Bulletin # SR-5R-1309-02

SAFETY BULLETIN

| Ride Name: Zero Gravity | Affected Serial #'s: 0404125-5R FORWARD |

| TITLE DETAILS BOOM REINFORCEMENT PLATE ZERO GRAVITY | | | | |

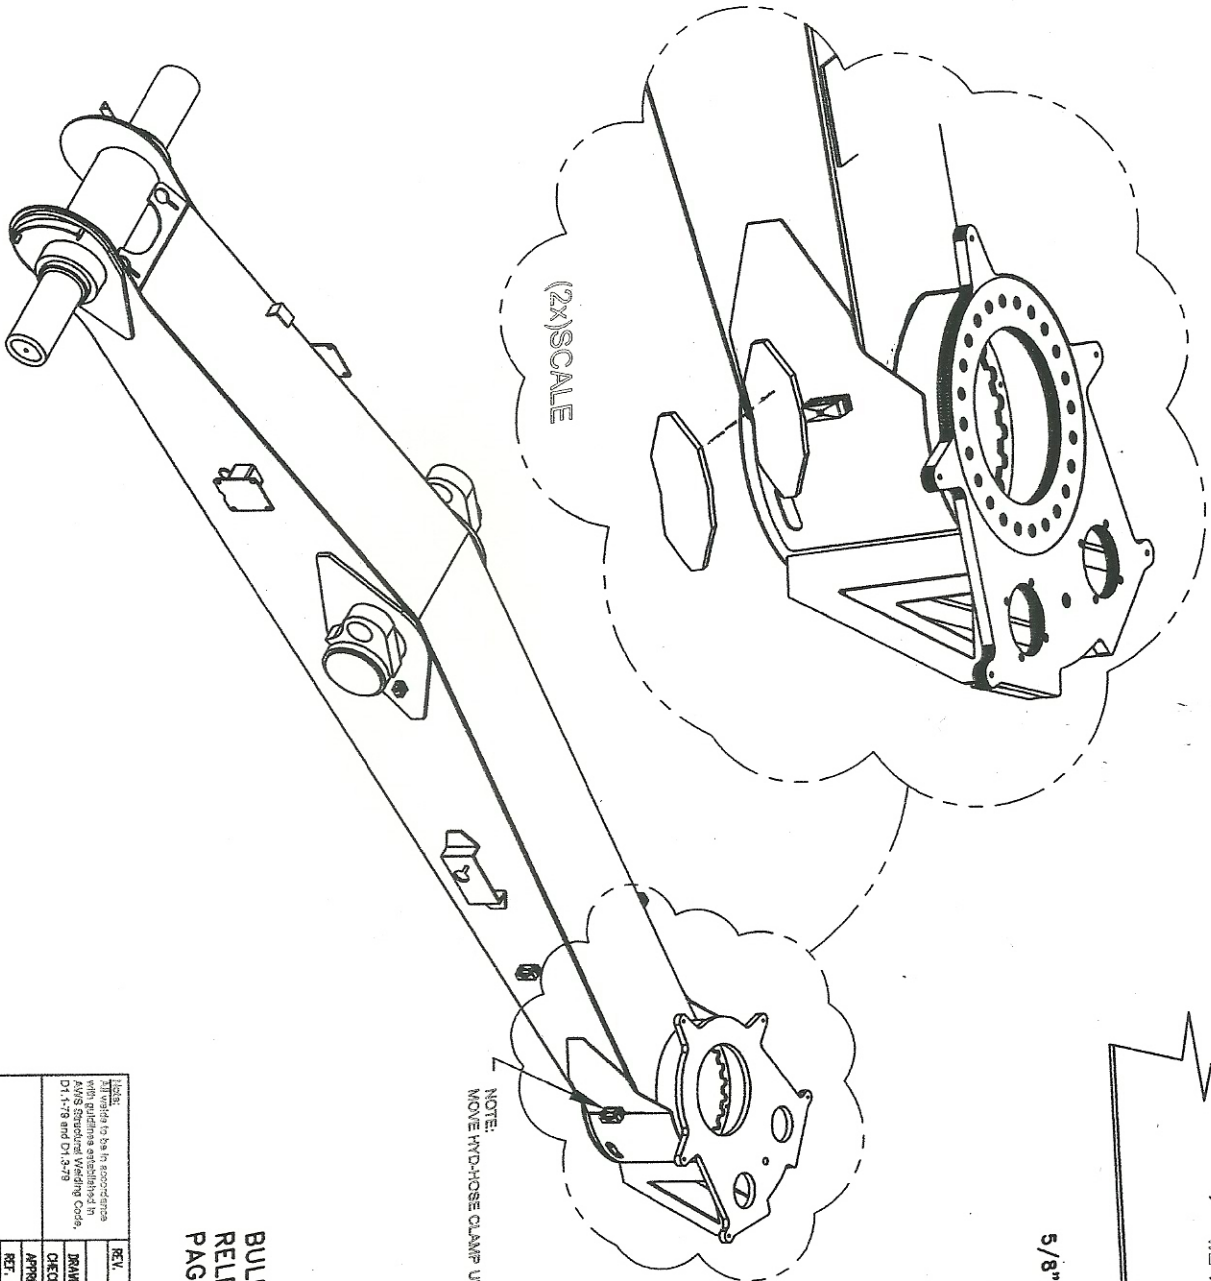
Abstract of Issue: Early production Dartron Industries, Inc. Zero Gravity amusement rides were produced using a thinner material on the boom drum and boom reinforcement plates. Cracking has been discovered in this area. Testing has determined that ALL Zero Gravities may eventually develop cracking in the same area.

Reason for release: To notify all owners, operators and inspectors of a safety concern with the booms on the Zero Gravity. Subsequent testing has determined that a reinforcement plate is required to insure that this area will not develop cracks at a future time. Failure to add these reinforcement plates may eventually result in the boom drum (bearing base) not adequately supporting the center bearing. A failure in this area could result in injuries.

5. The ground must be connected as close to the weld location as possible to insure that the current does not pass through any bearings
6. Tack securely in place approximately 5/8" from the bottom edge and parallel to it. See the attached illustration on page 4 of this bulletin.

7. Preheat the joint to at least 100 degrees Fahrenheit.
8. Weld the joint with 7018 electrode using DCEP (reverse polarity). Apply stringers in the horizontal and overhead positions. Clean between passes and continue to weld until a 1/2" fillet weld is achieved. **DO NOT WELD THE VERTICAL ENDS.**
